DECISION, CONDITIONS, FINDINGS OF FACT, AND CONCLUSIONARY FINDINGS OF THE MCMINNVILLE HISTORIC LANDMARKS COMMITTEE FOR APPROVAL OF THE ALTERATION OF A HISTORIC RESOURCE AT 711 NE 3RD STREET

- DOCKET:** HL 5-18
- REQUEST:** The applicant has submitted a Certificate of Approval application to request the alteration of a historic resource that is located within the Downtown Historic District that is listed on the National Register of Historic Places and is also listed on the McMinnville Historic Resources Inventory.

The proposed design for the reconstructed storefront window systems and entries can be seen below:

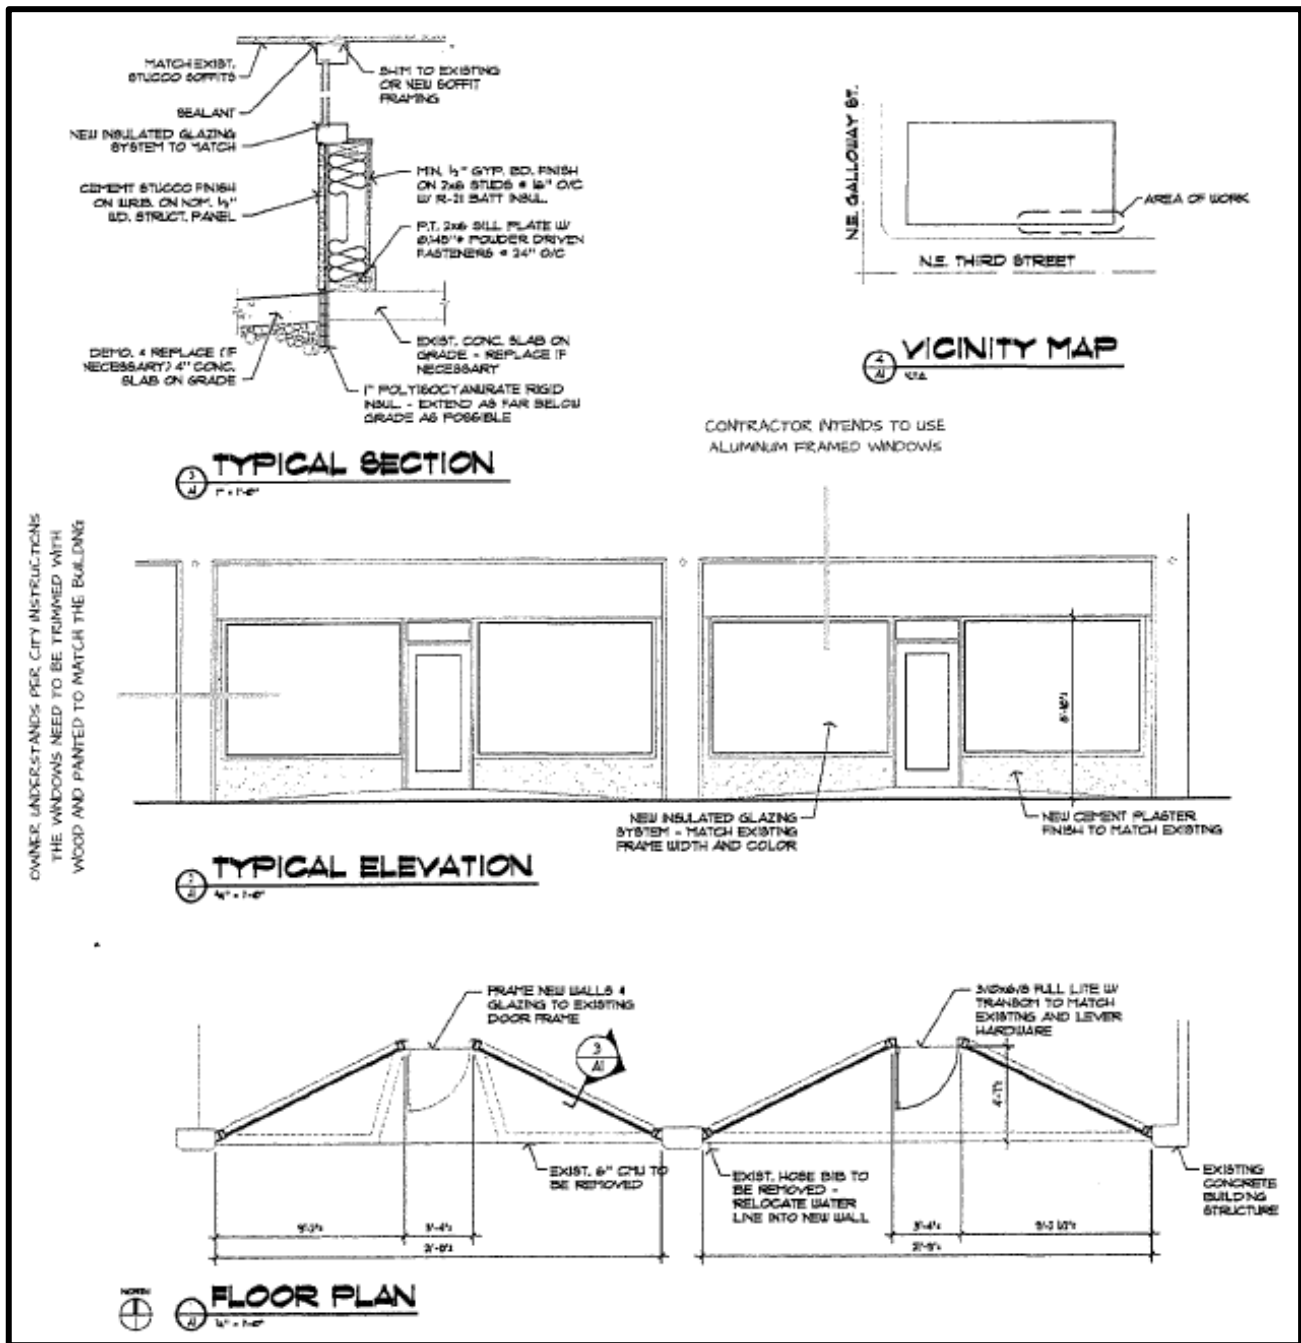
1. That the stucco bulkheads beneath the storefront windows shall be painted the same grey color as the windows and window frames on the remainder of the building in order for the historic storefront bay system and columnar stucco pilasters to be more prominent. The bulkheads beneath the storefront windows along the entire south façade, including the two bays proposed to be rehabilitated and the two existing bays to the west, shall all be painted the same grey color to ensure consistency along the entire south façade.
2. That the applicant shall submit building permit applications prior to completing any work, and that the construction plans submitted with the building permit applications shall be consistent with the exhibits, drawings, and renderings submitted for review by the Historic Landmarks Committee, and consistent with all applicable conditions of approval.

Additionally, the design has inadequate maneuvering clearance for ADA on the latch side of the doors.

The glazing that will go adjacent to the doors will need to be safety glazing as well as the glazing within the doors.

Door hardware must be ADA compliant (e.g., lever-type).

The threshold height is not indicated but must be held to a maximum of ½ inch for ADA.

If the awnings are to remain, it appears they will need to be remounted with the façade change.
